ADDENDUM NO. 2

Date: 16 MAY 2025 **SDG Project No.:** 2421

Project Name: Holland M. Ware Park at McGee Field

SHT.<u>**07**</u> of <u>**15**</u>

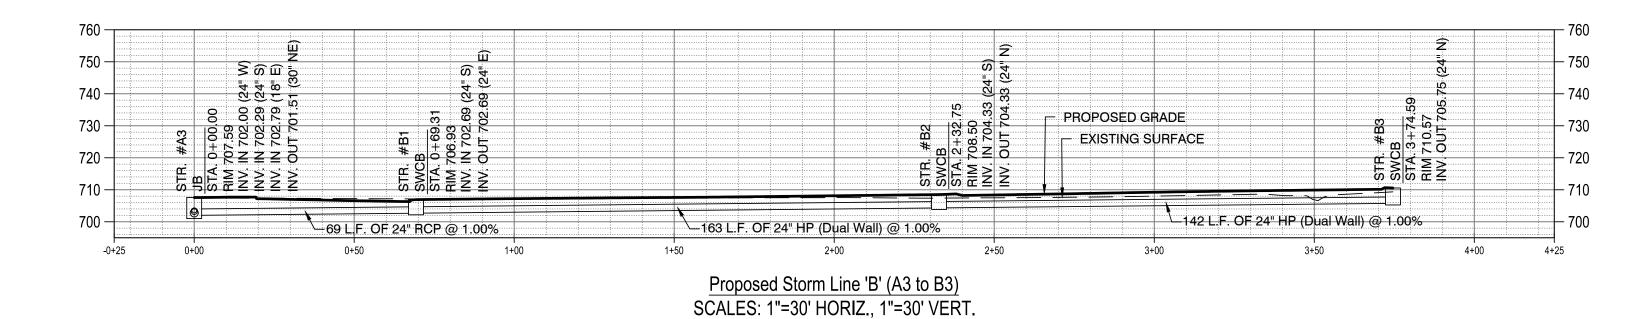
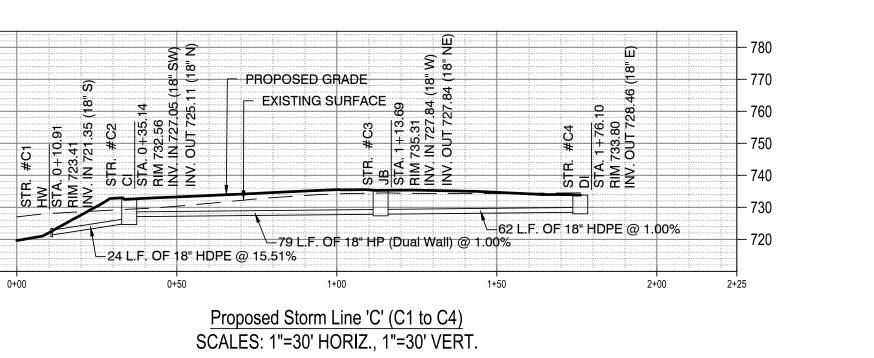
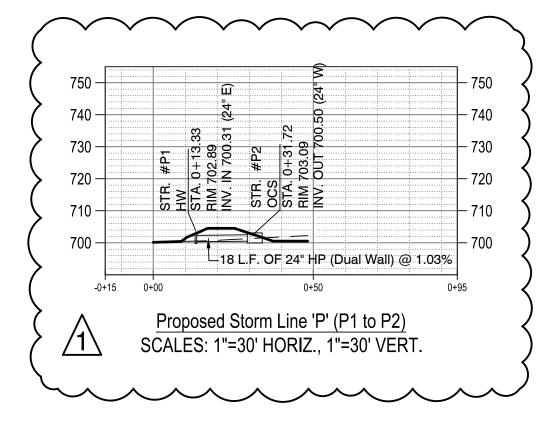
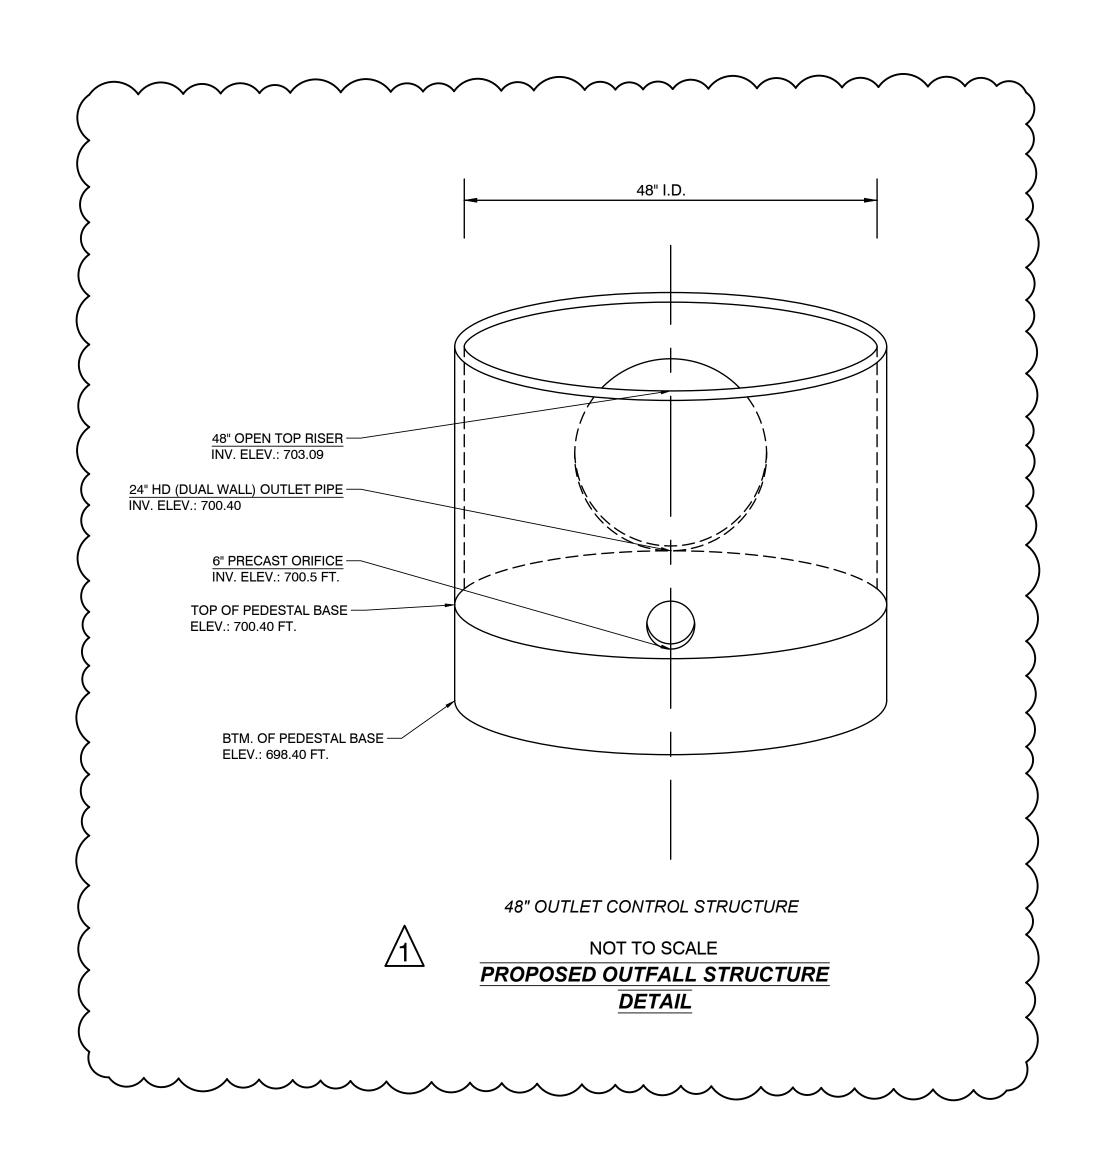
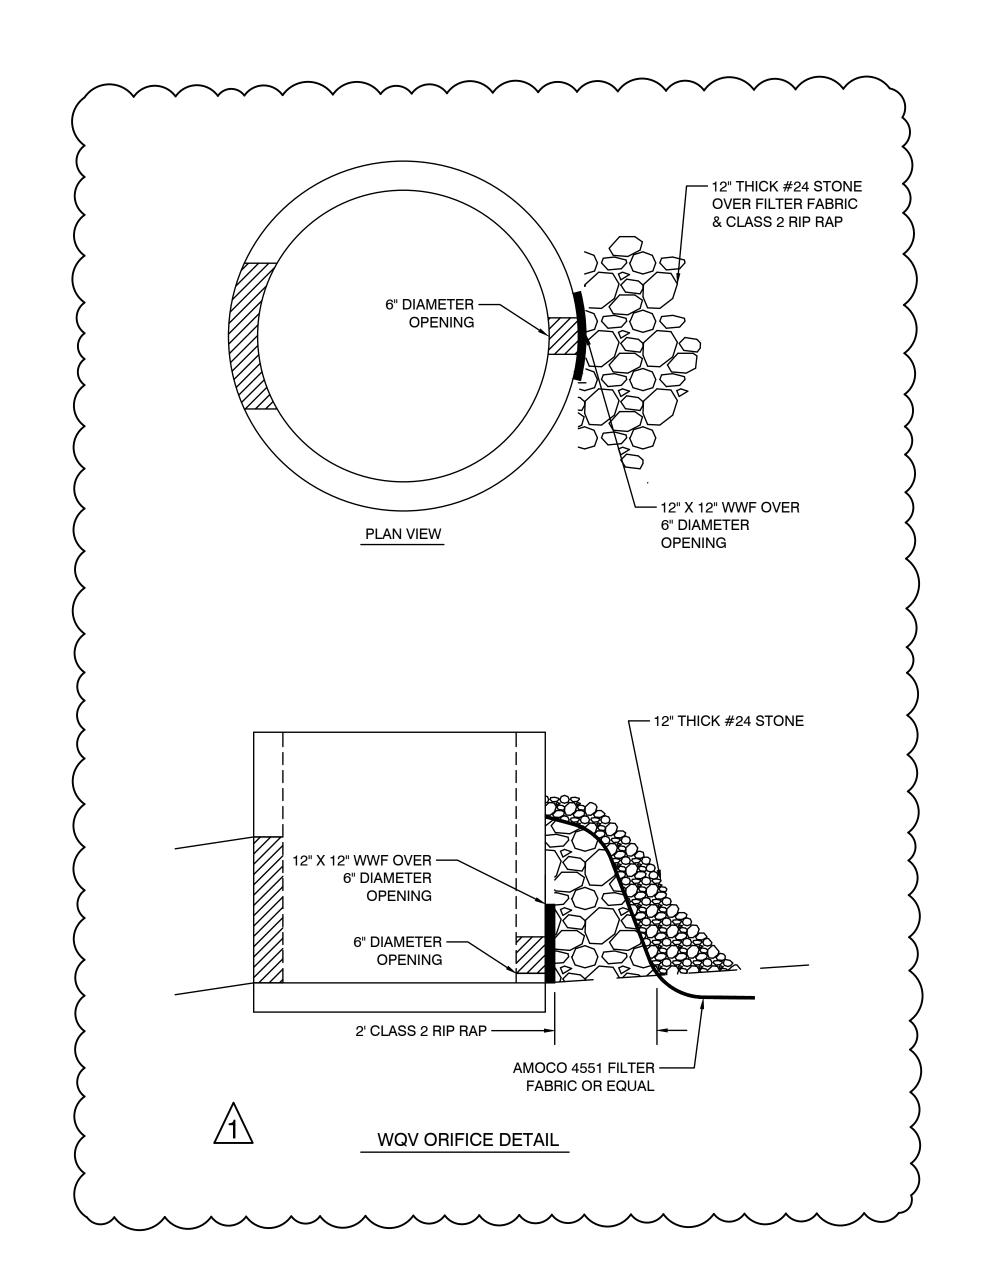
A. Storm pipe size and type for line P, between structures "P1" and "P2" to be 30"; refer to sheet EC 09 of 13.
